August 13, 1985  
Contract No. 02-82-044  
Fin No. B-7372-3  
Communication No. 138

We have reviewed the document entitled "Numerical Modeling of the Ground Water Flow System at the Location, Hanford Site, Washington." We recognize that this is a rough draft of the early chapters of the document to be produced by SANDIA. We have enclosed a marked up copy of this rough draft to facilitate the conveyance of our comments. We have noted some minor editorial points which are more easily conveyed in this manner. We do have several major comments.

# NUMERICAL MODELING OF THE GROUND-WATER FLOW SYSTEM AT THE LOCATION, HANFORD SITE, WASHINGTON

Figure 2-1. Location of the Hanford Site, southeastern Washington State.

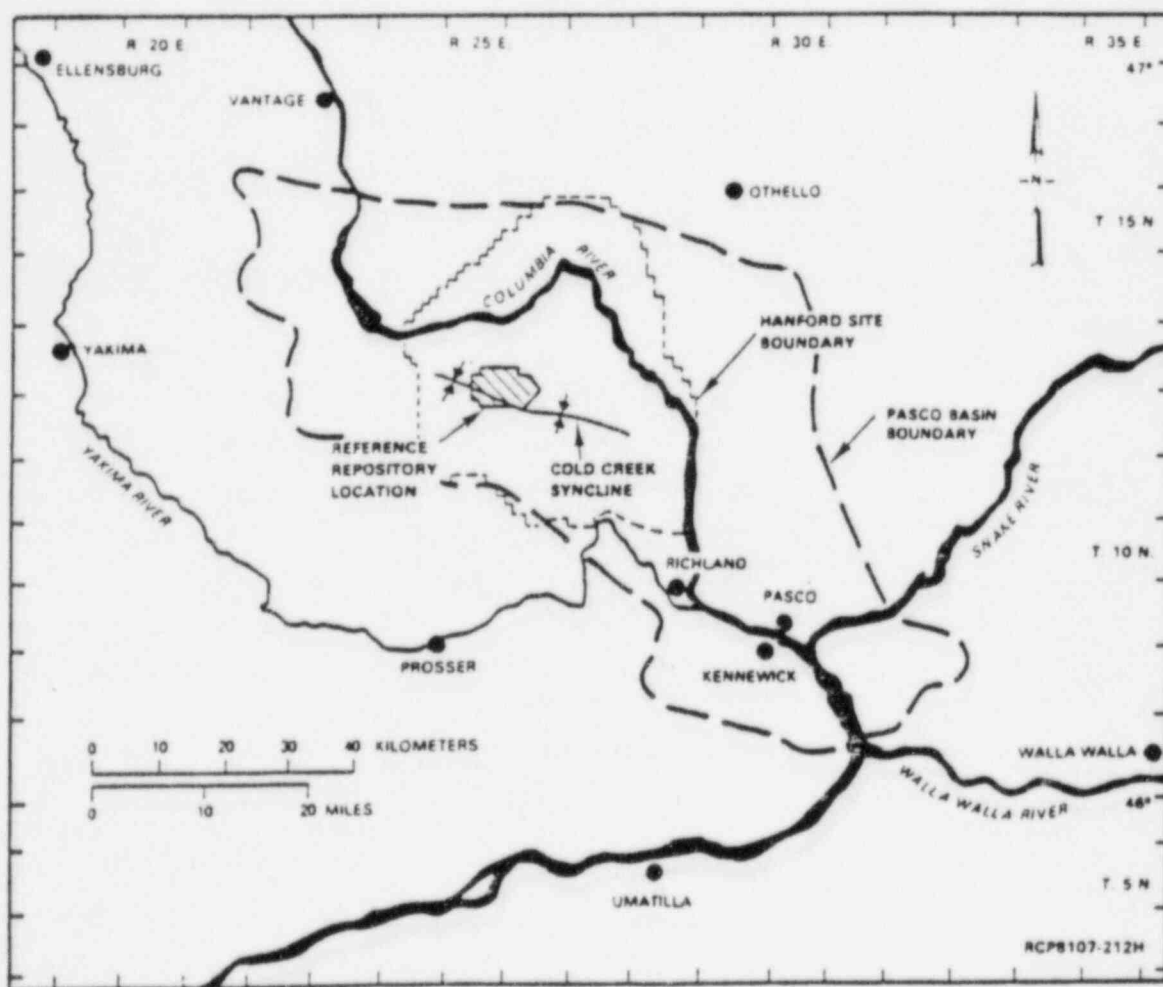
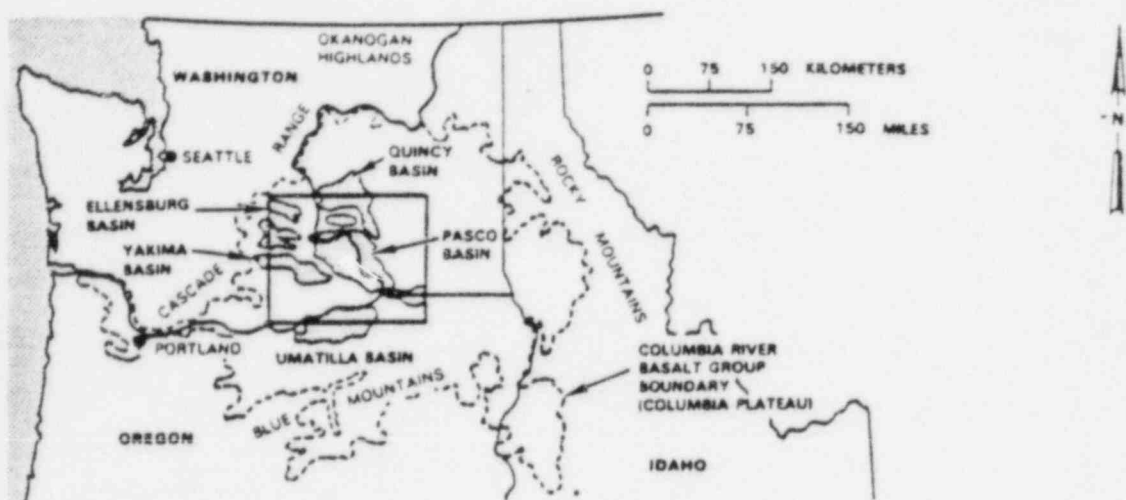
\* insert a more detailed discussion of the purpose of this document stating what the major topics are in this document

Figure 1-14. Isopach map of the dense interior of the McCoy Canyon flow.

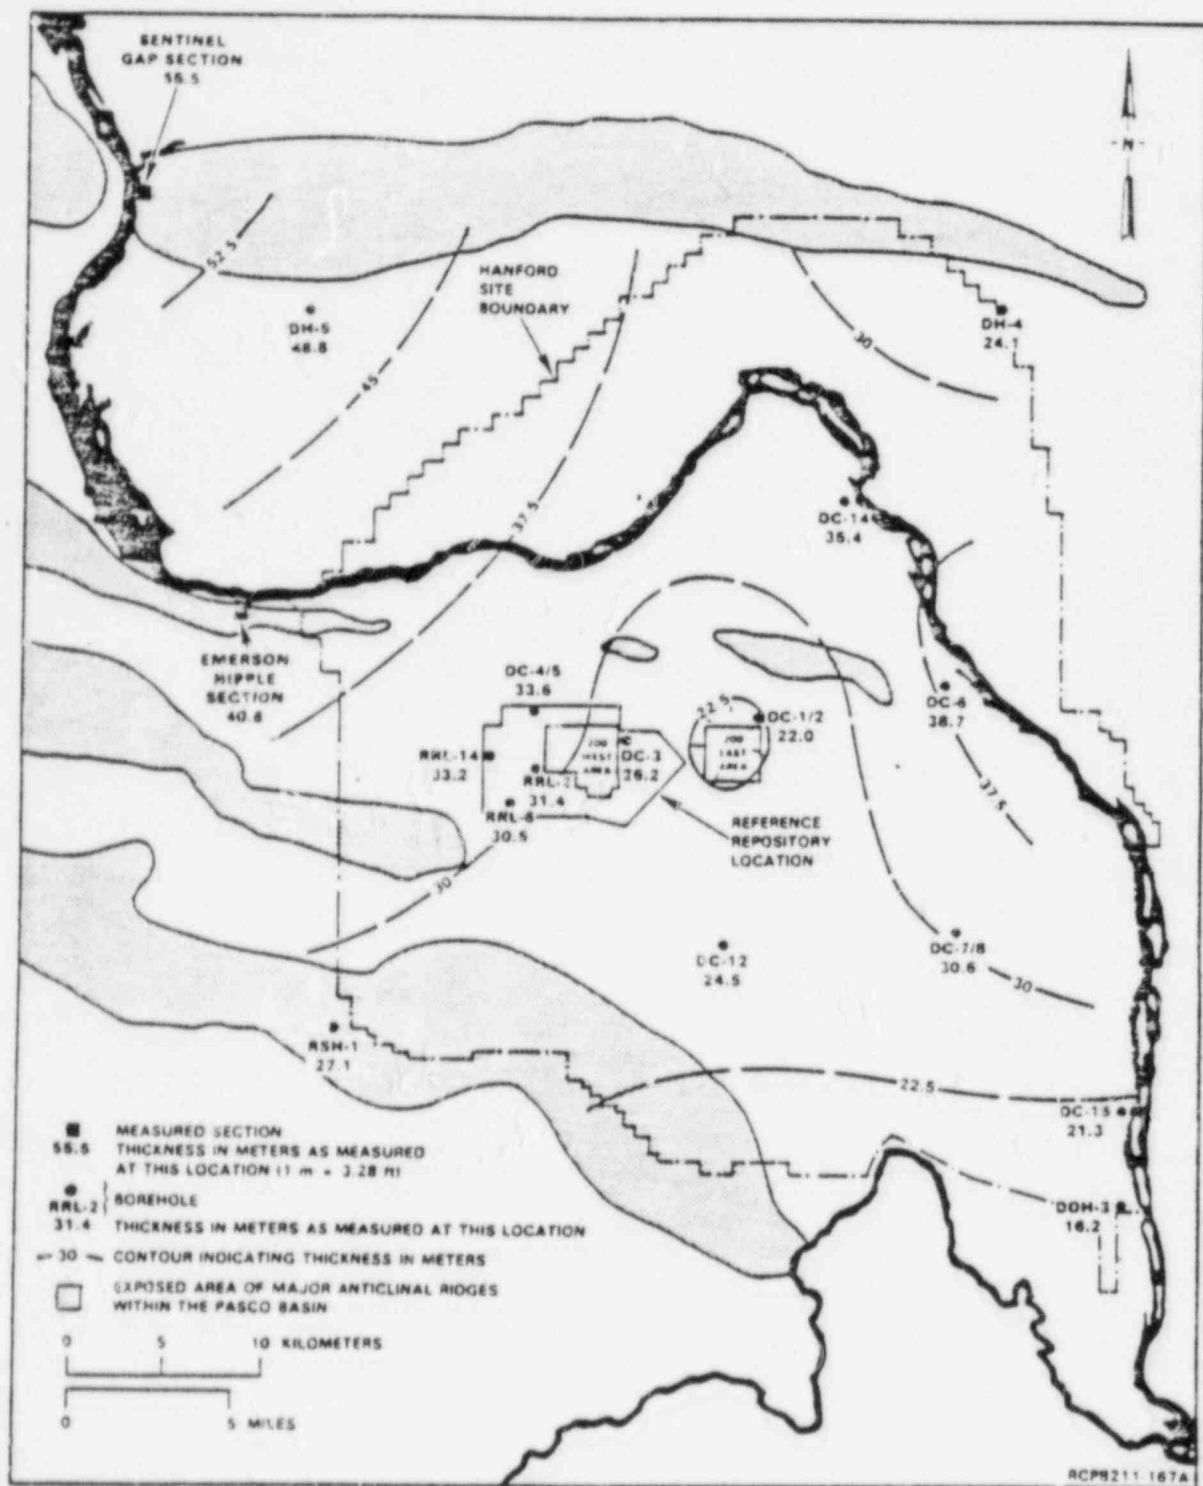
not correctly referenced  
in text

Figure 3-9. Sentinel Bluffs sequence isopach map.

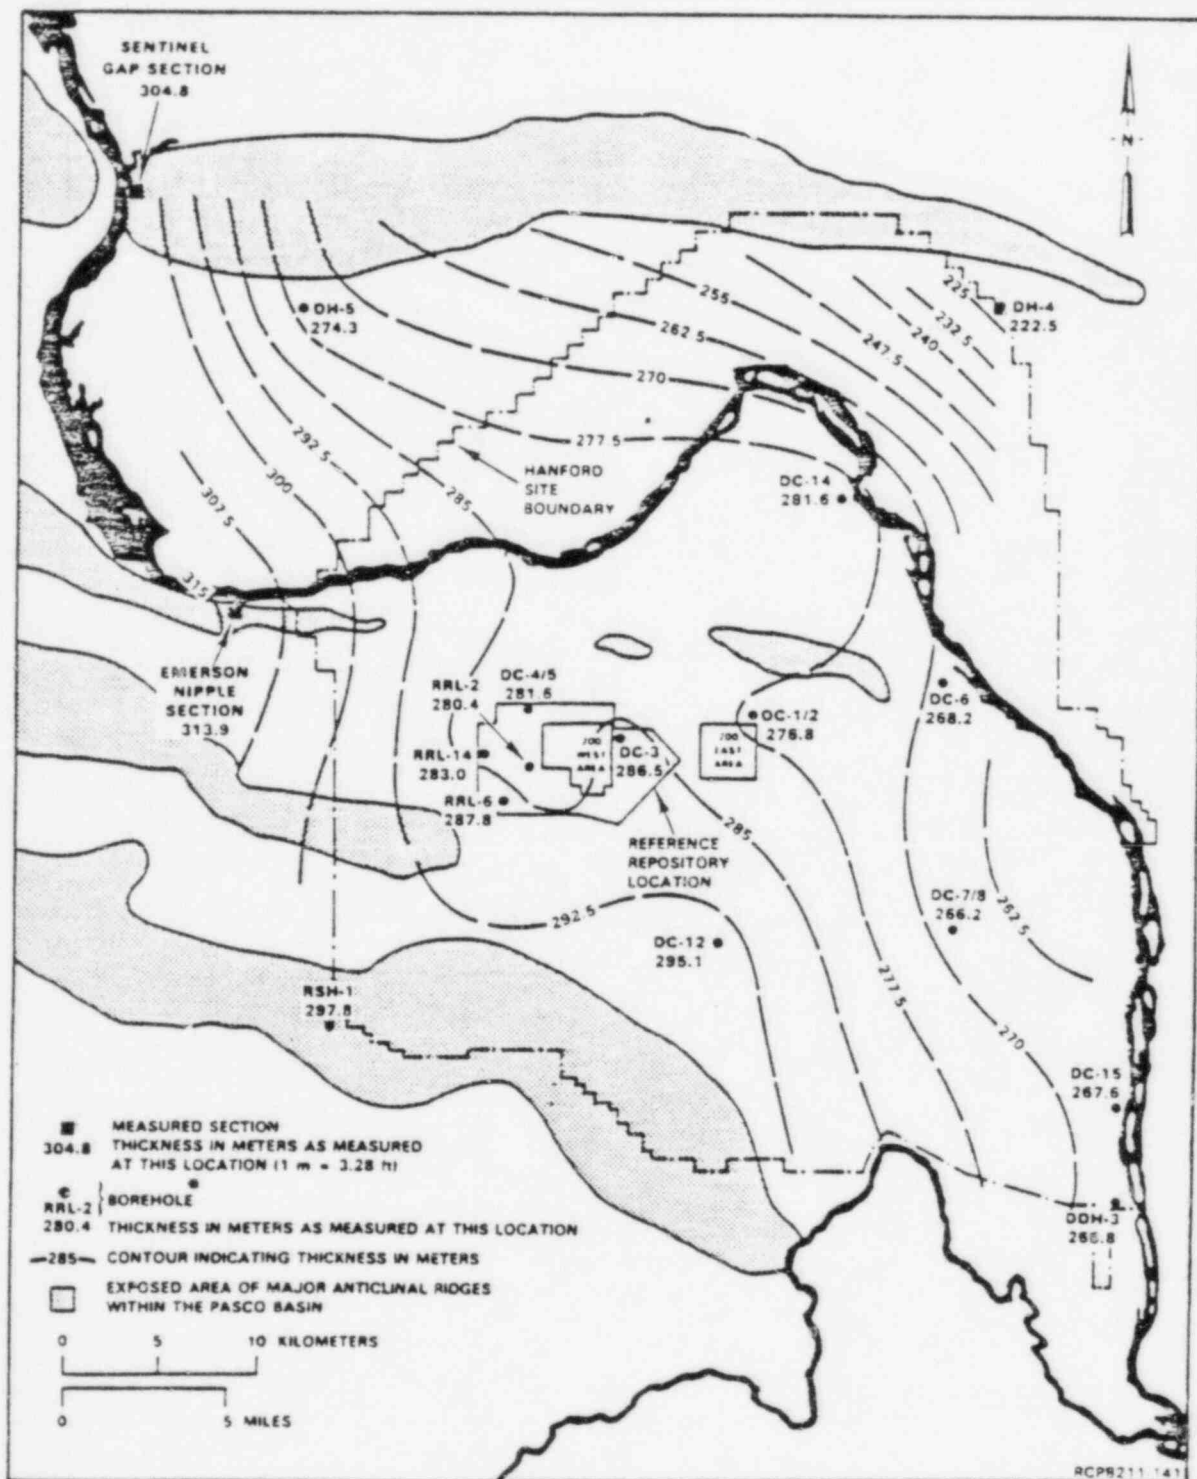
Figure not referenced

Figure 8. Extent of the Columbia River Basalt Group, Pasco Basin, and reference repository location.

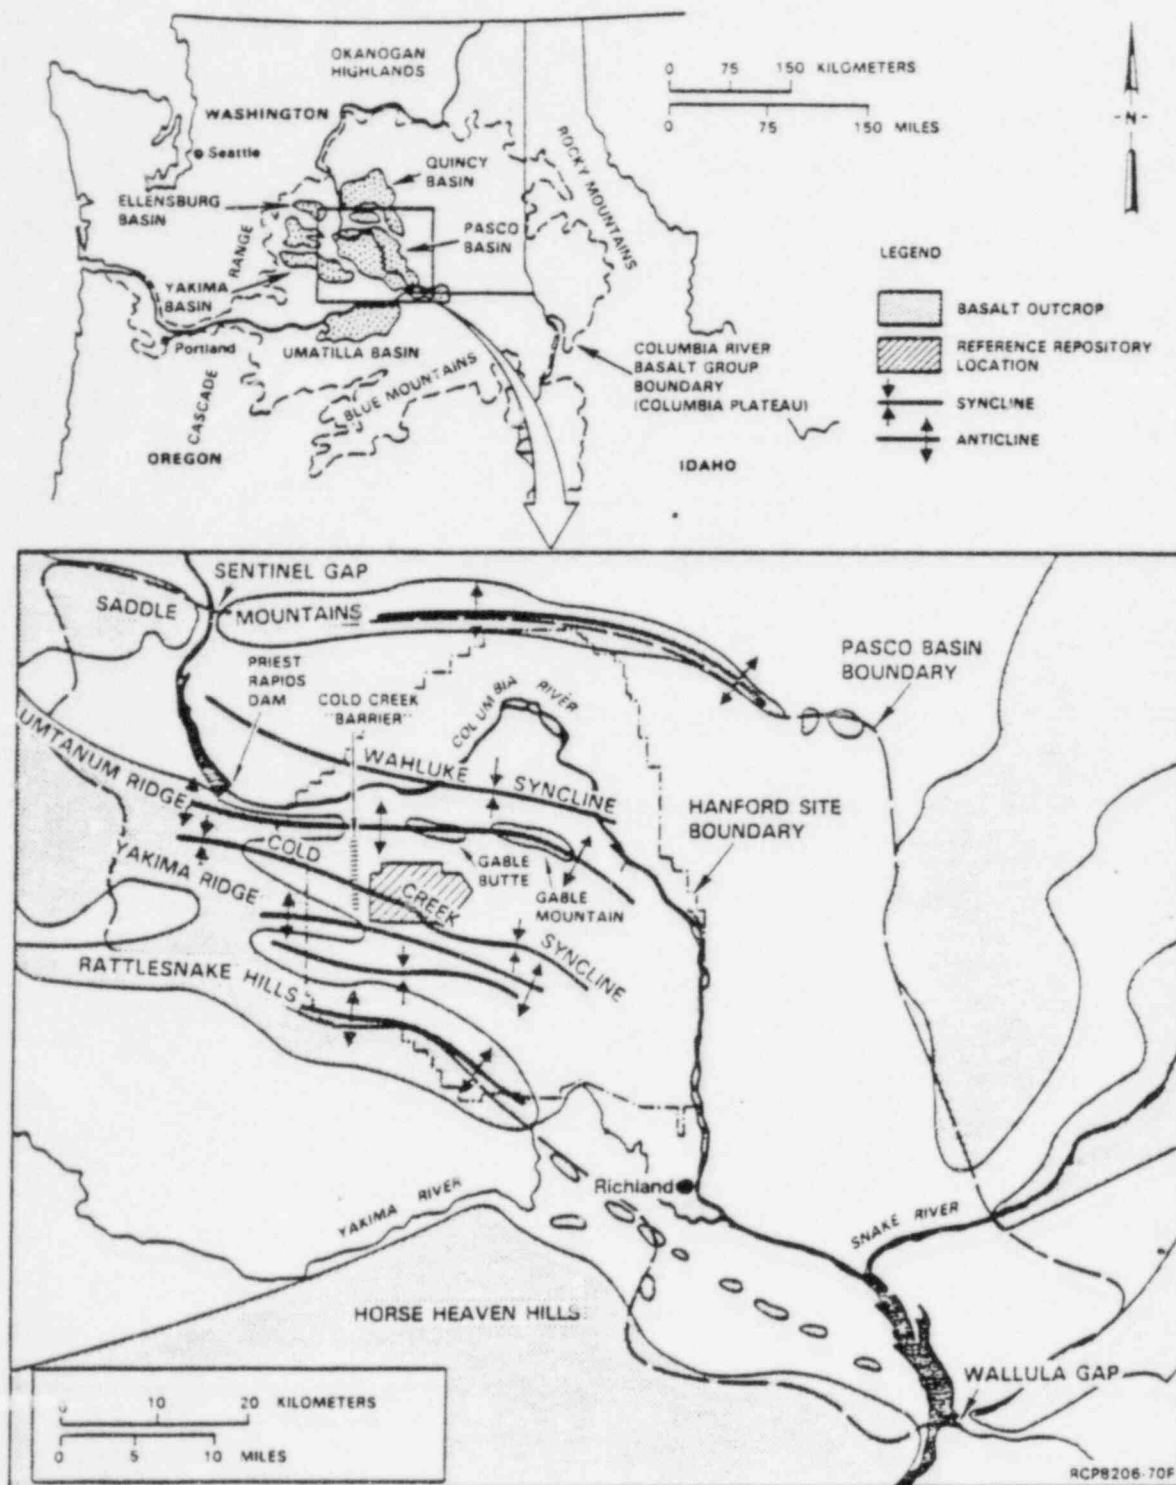
\* consider expansion to include Fig 3-52 from SCR - there are other hydrogeologically relevant structures that should be discussed

FIGURE X. Plan View of Three-Dimensional Finite Element Network for Pasco Basin.

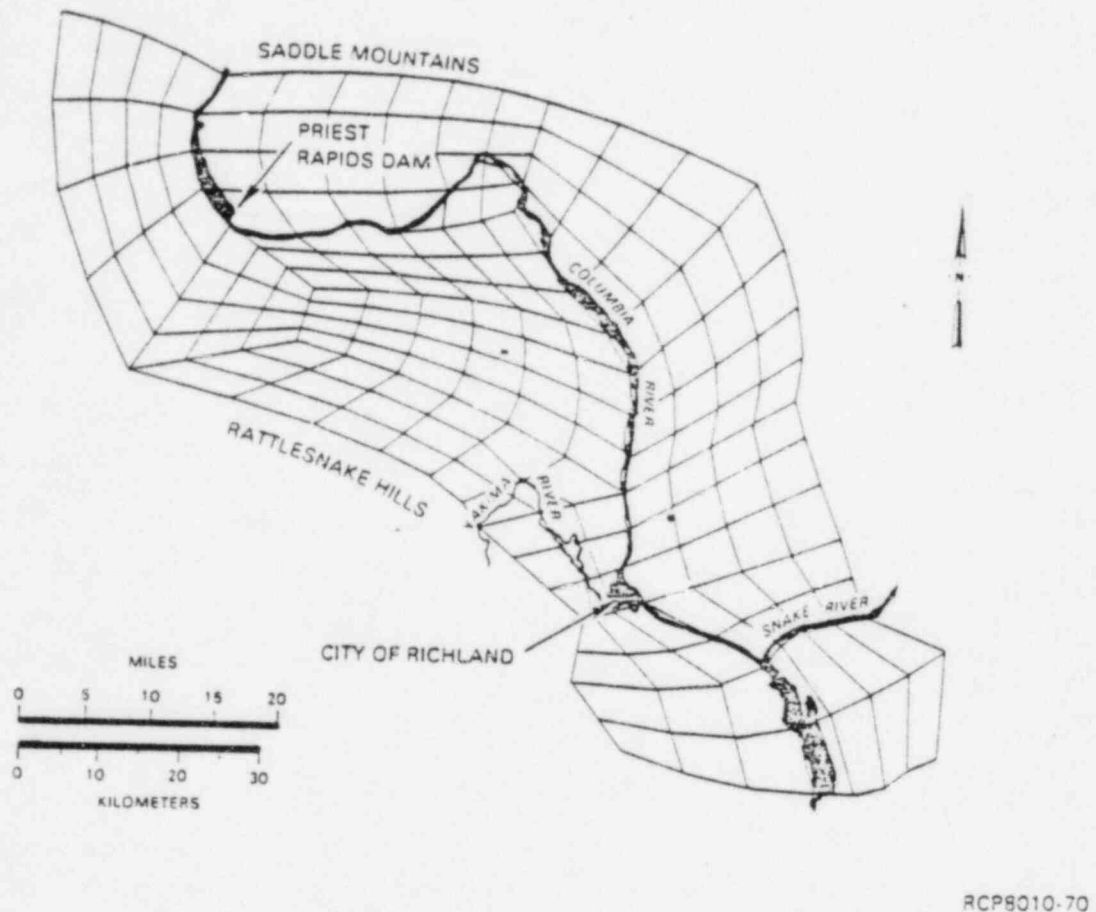
grid appears to be too large in vicinity of RRL  
for stable solutions involving large head differences -  
grid is probably adequate for steady-state analysis
